FED. ROAD DIST. NO.	STATE	PROJ. NO.	FISCAL YEAR	SHEET NO.	TOTAL SHEETS
HAWAII	HAW.	11B-01-20	2022	C.O. 20	34

ROADWAY PLAN DETAIL

KUAKINI HIGHWAY DRAINAGE IMPROVEMENTS
Vicinity of Mile Post 114
Project No. 11B-01-20

SHEET No. P-3 OF 10 SHEETS

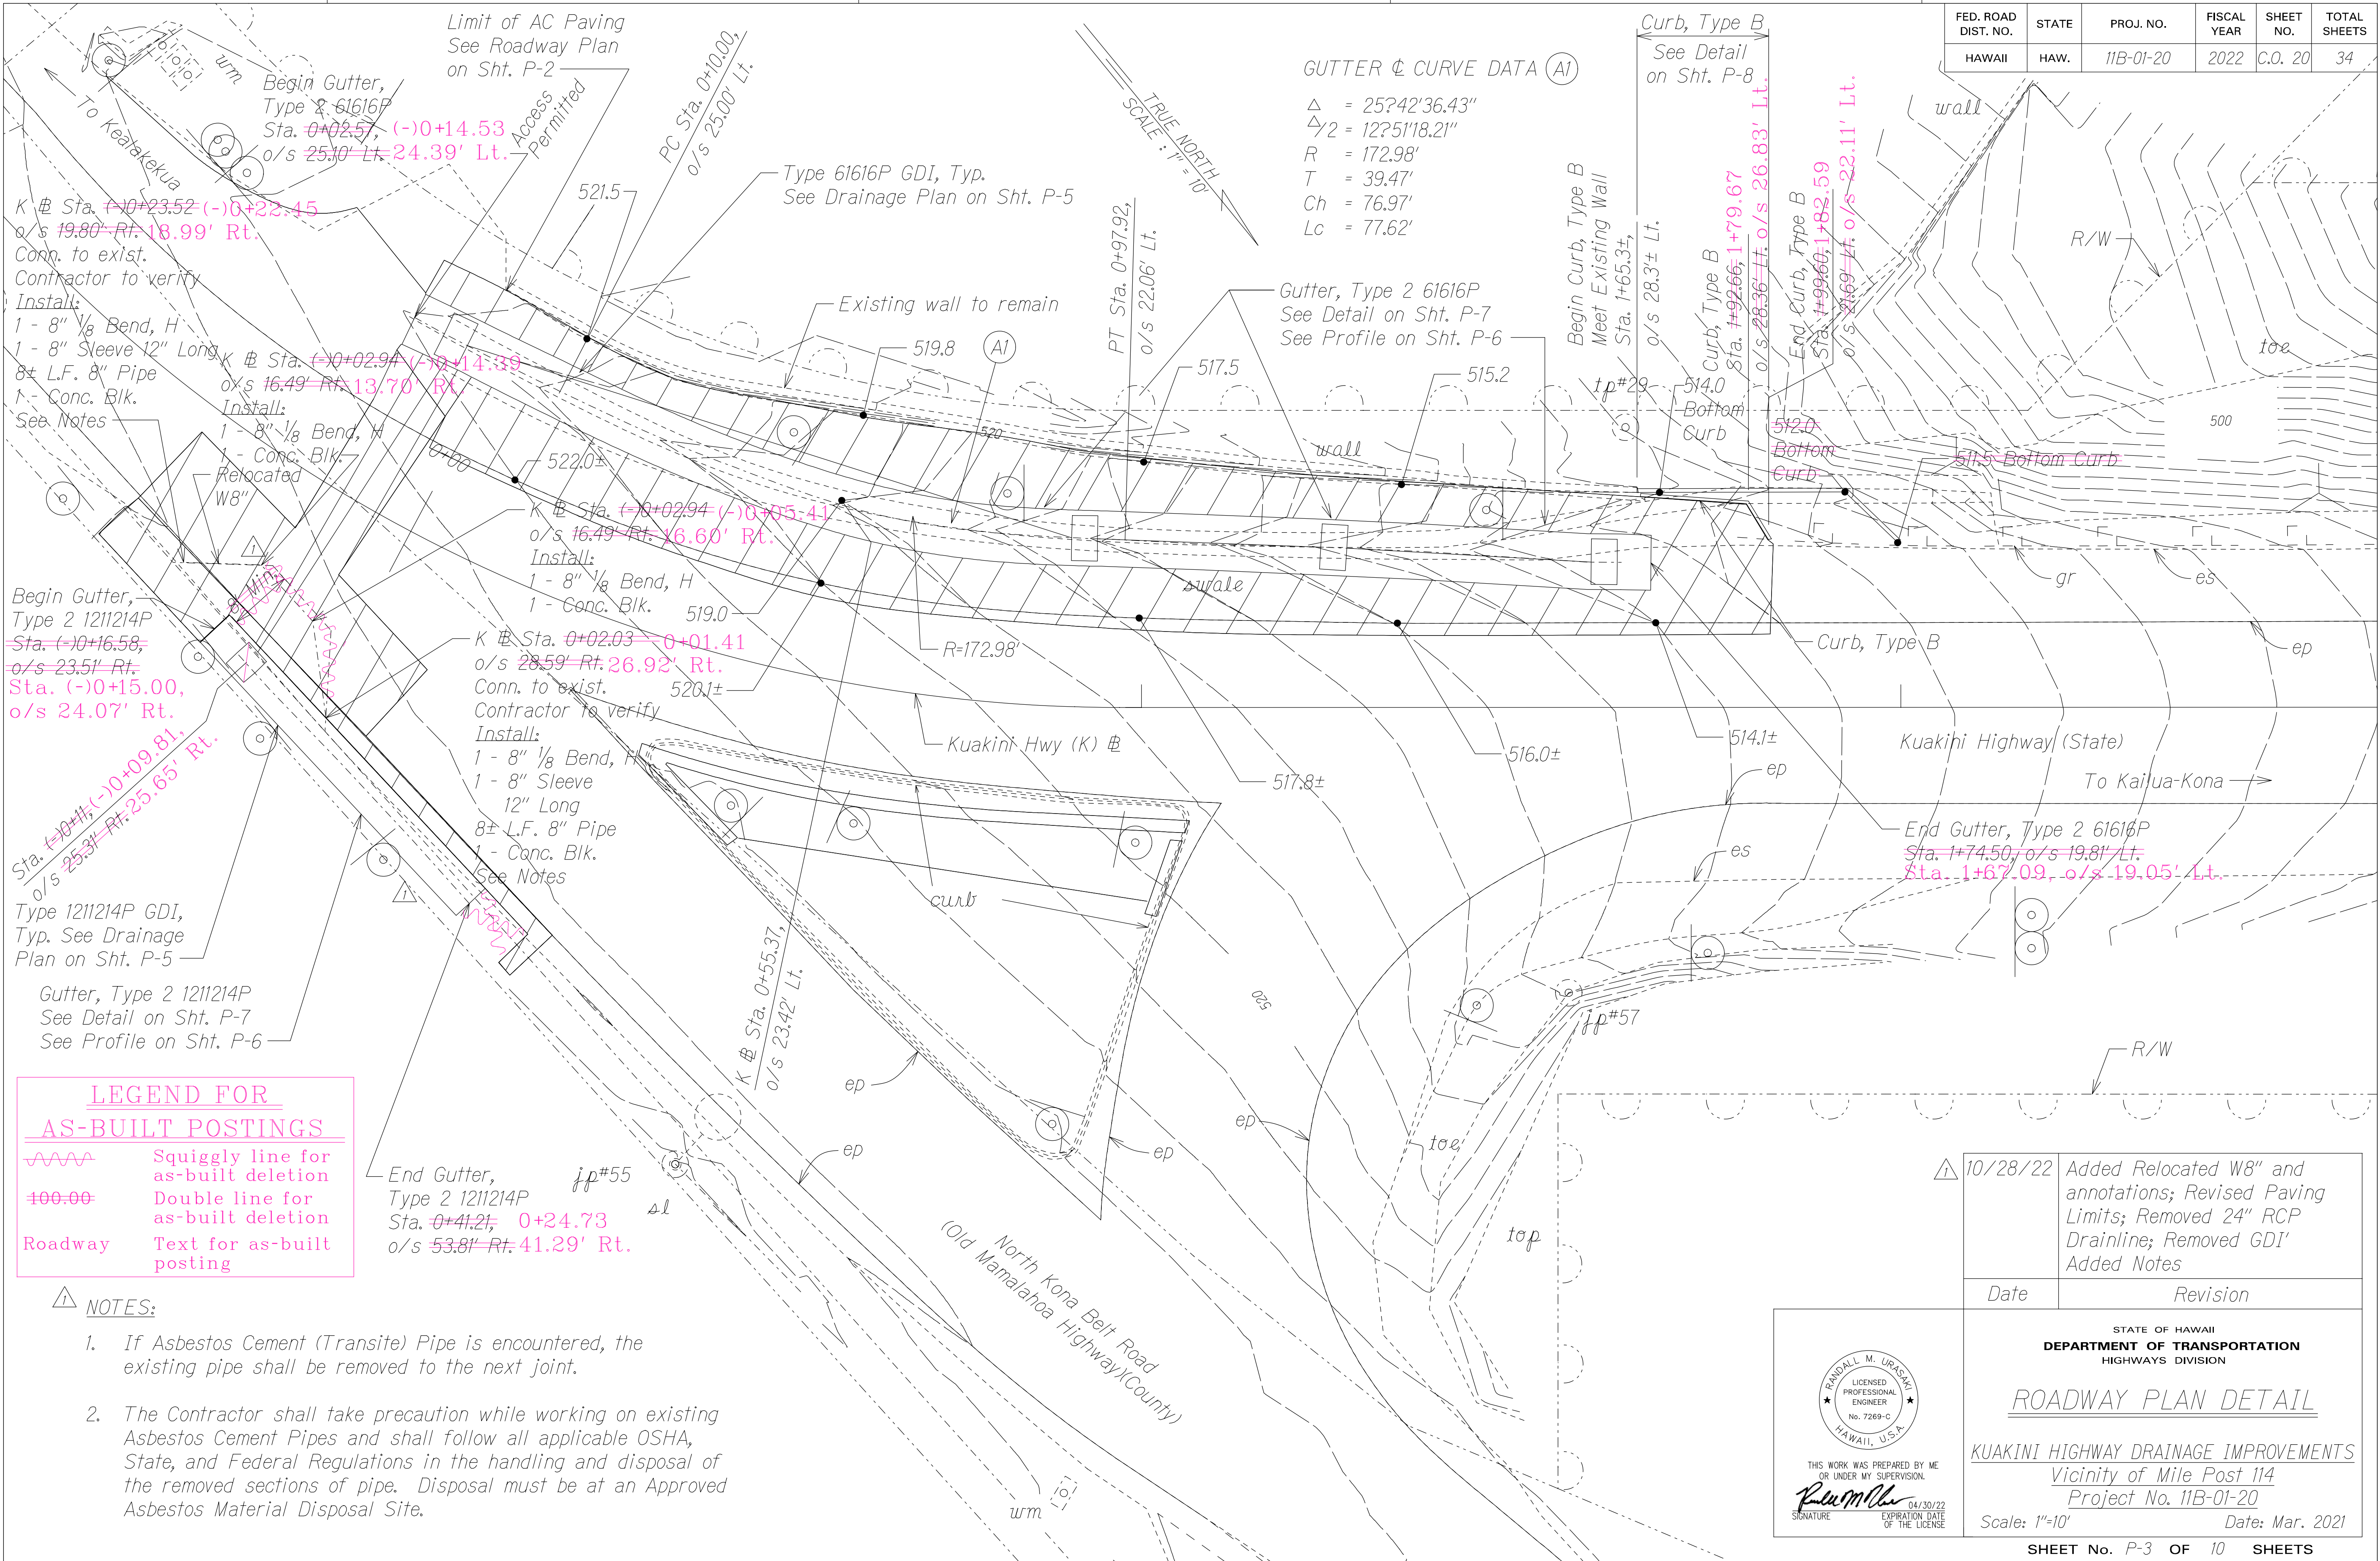
10/28/22	Added Relocated W8" and annotations; Revised Paving Limits; Removed 24" RCP Drainline; Removed GDI' Added Notes
Date	Revision
